T18SZ SOFTWARE UPDATE CHANGES

V4.3

This software updates or alters the functions and features noted below. The instructions and information that follow are meant as a supplement to the original instruction manual that accompanied the T18SZ transmitter. Please refer to the original instruction manual where applicable, but replace the steps indicated below with these instructions. Please check to ensure that the update has been installed.
1) Select the System Menu.
2) Touch the [Information] button.
3) Confirm that the information in the display indicates the version numbers as noted above.

◆ **Airspeed sensor is registered with the transmitter.**

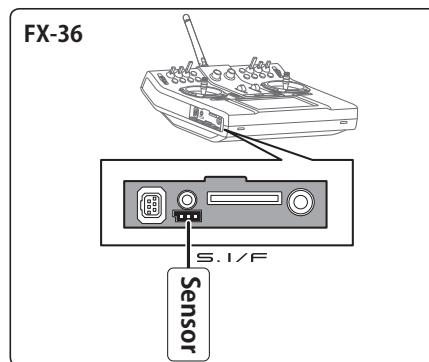
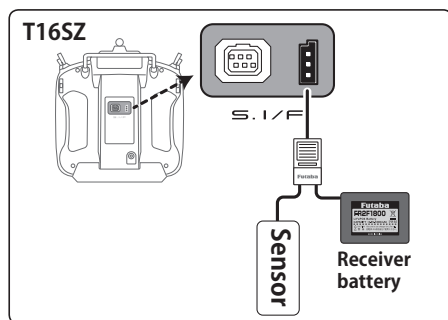
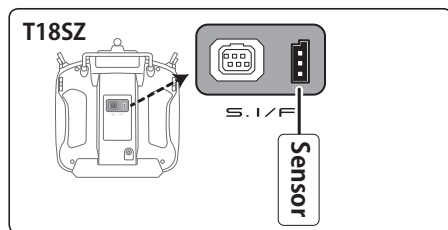
1. Telemetry Airspeed sensor function

The T18SZ/T16SZ/FX-36 has been made compatible with the telemetry airspeed sensor.

① **Connect the sensor to the transmitter as shown in the figure.**
② **[Linkage menu] → [Sensor] → [Page 3/3] is opened from the transmitter.**
③ **Tap [Register]**
④ **Complete registration and remove sensor from the transmitter.**

2. Timer Alarm

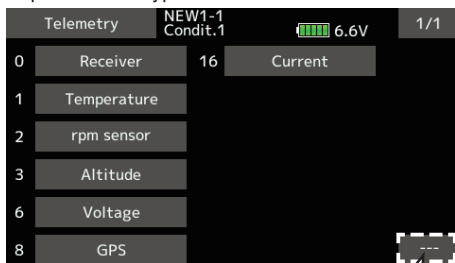
Added a setting to continue the alarm after the alarm set time.

Constant: The alarm does not stop
One time: Stop the alarm at once
